Decision Date: September 24, 2018

RE: Vesting Tentative Tract No. VTT-74964-SL
Related Case: N/A
528 North Hayworth Avenue
Hollywood Planning Area
Specific Plan Subarea: N/A
Zone: R3-1XL
Council District: 5
CEQA: ENV-2017-2284-CE
Legal Description: Lot 49; Tract 5244

REVISED VESTING TENTATIVE TRACT MAP 74964

FOR 6 UNIT SMALL LOT SUBDIVISION

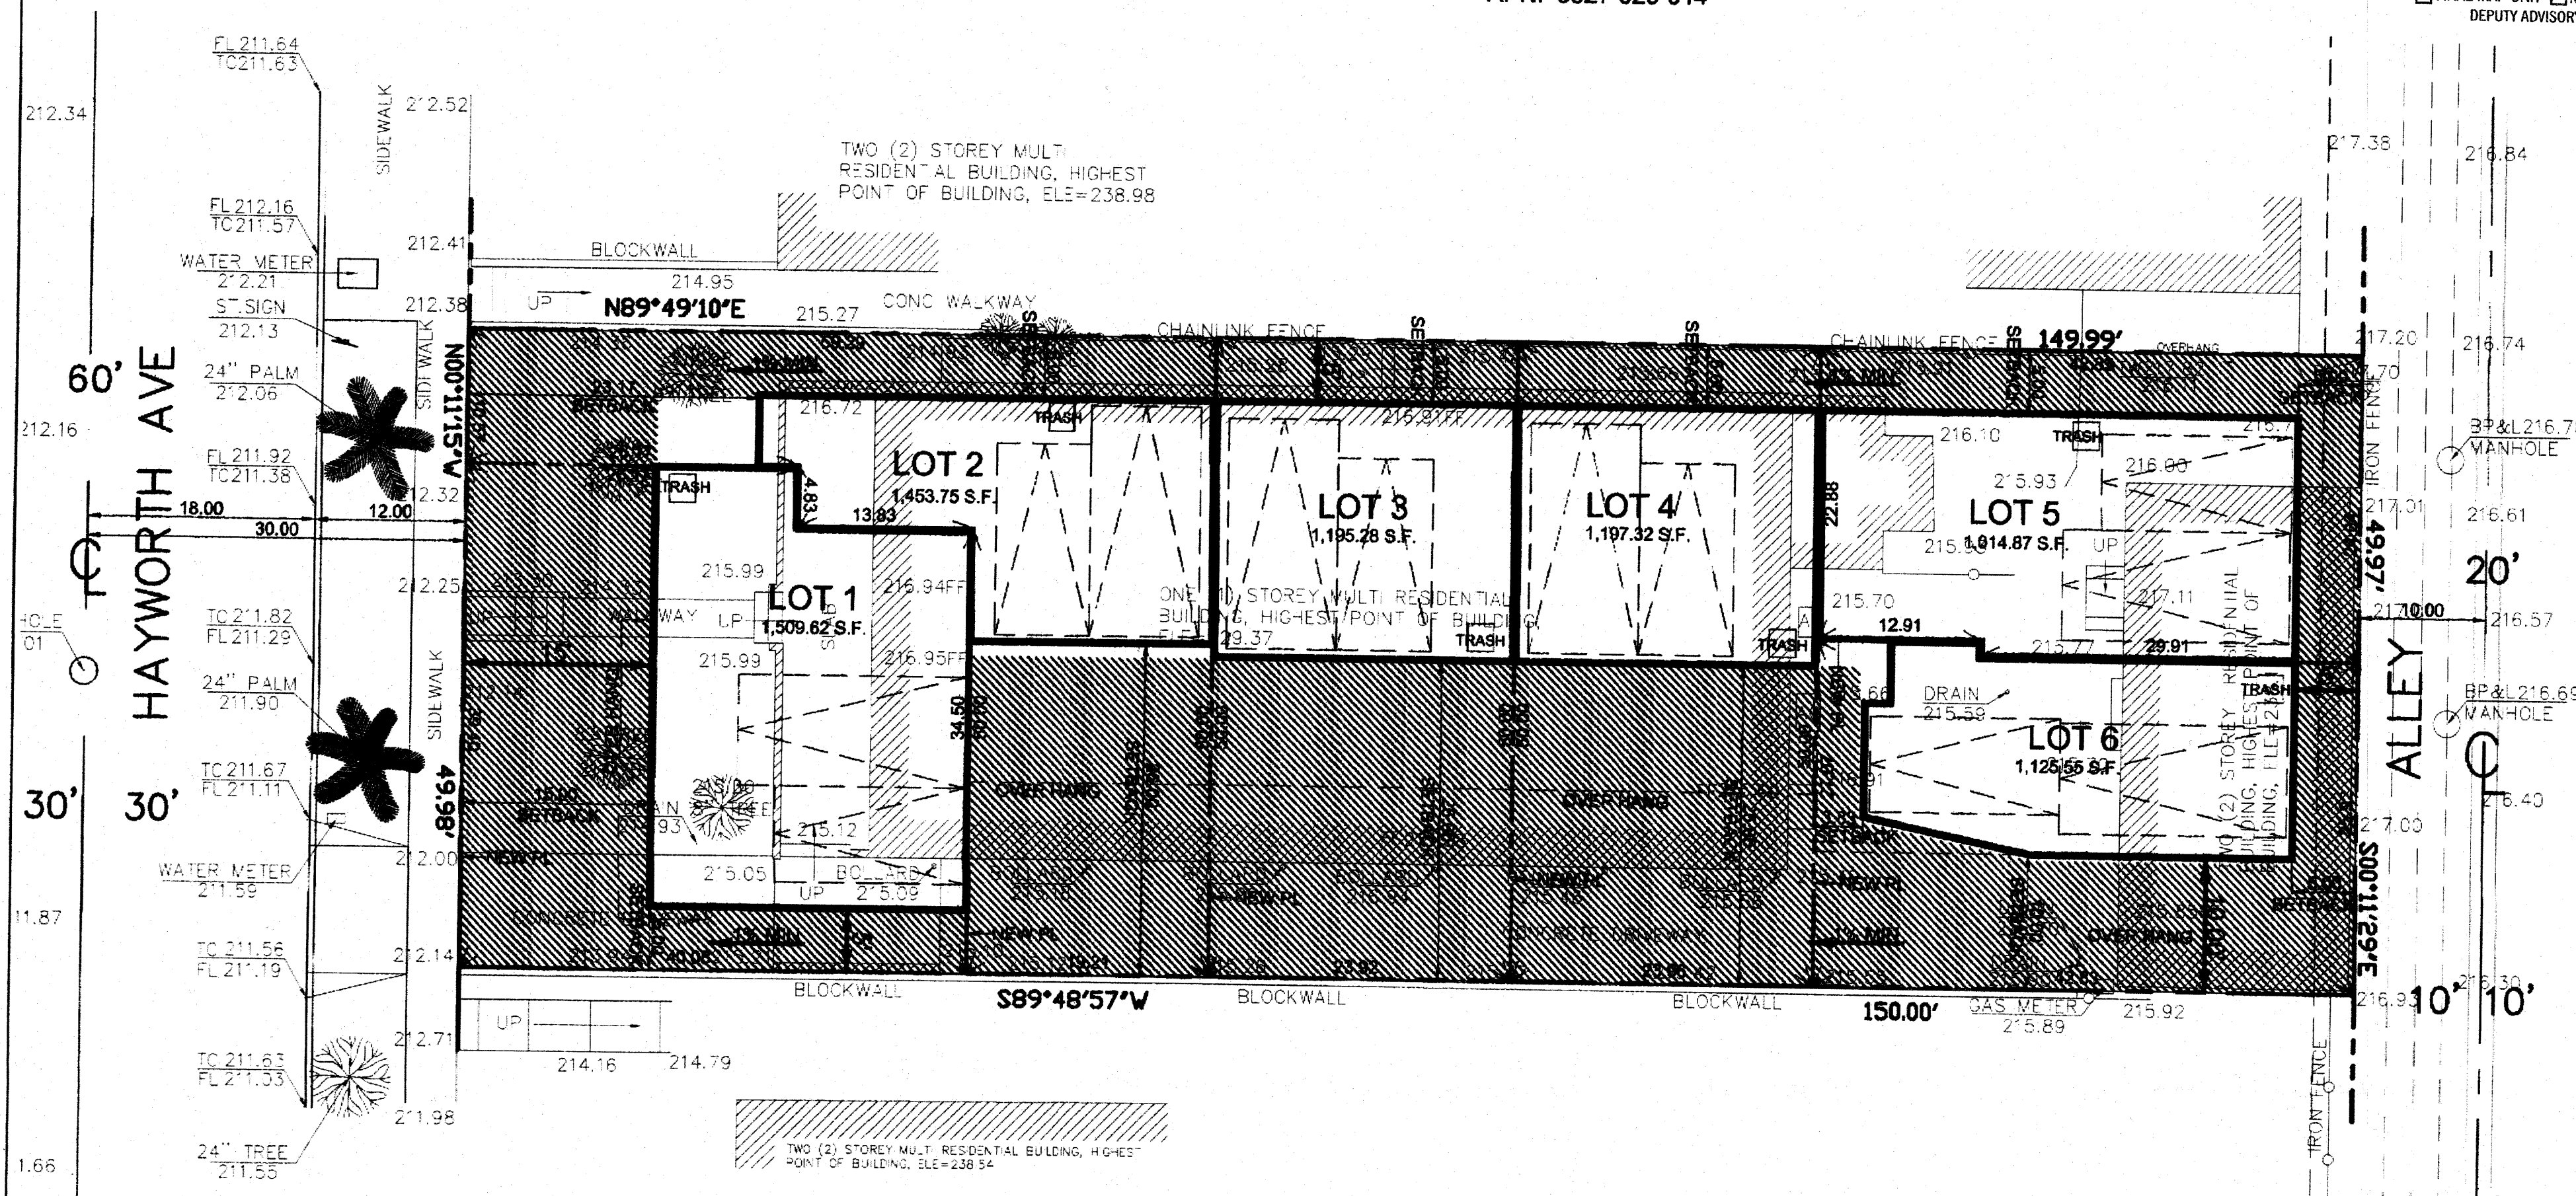
- c. Resubmit the map to provide and maintain a minimum 20 ft. common access strip open to the sky for the lots all the way to the public street for access and frontage purpose per Section 12.03 under the definition of "Lot". No projections are allowed

into the 20 ft. minimum common access strip. Provide the 20 ft. wide common access open to the sky or obtain approval from the City Planning Advisory Agency to allow for a reduced and/or projection into the common access strip all the way to the public street.

- d. Dimension the reciprocal private easement for pedestrian and driveway egress and ingress, back up space, drainage, and utilities on the final map.

The submitted Map may not comply with the number of guest parking spaces required by the Advisory Agency.

Backup space for parking space with less than 26'-8" shall provide sufficient parking stall width and garage door opening width to comply with the current Zoning Code requirement. Comply with the above requirement at the time of Plan Check or obtain City Planning approval.

- a. The project shall comply with setbacks as indicated in the table below:

- b. The width of the common access driveway shall be a minimum of 10 feet and shall remain clear to the sky.
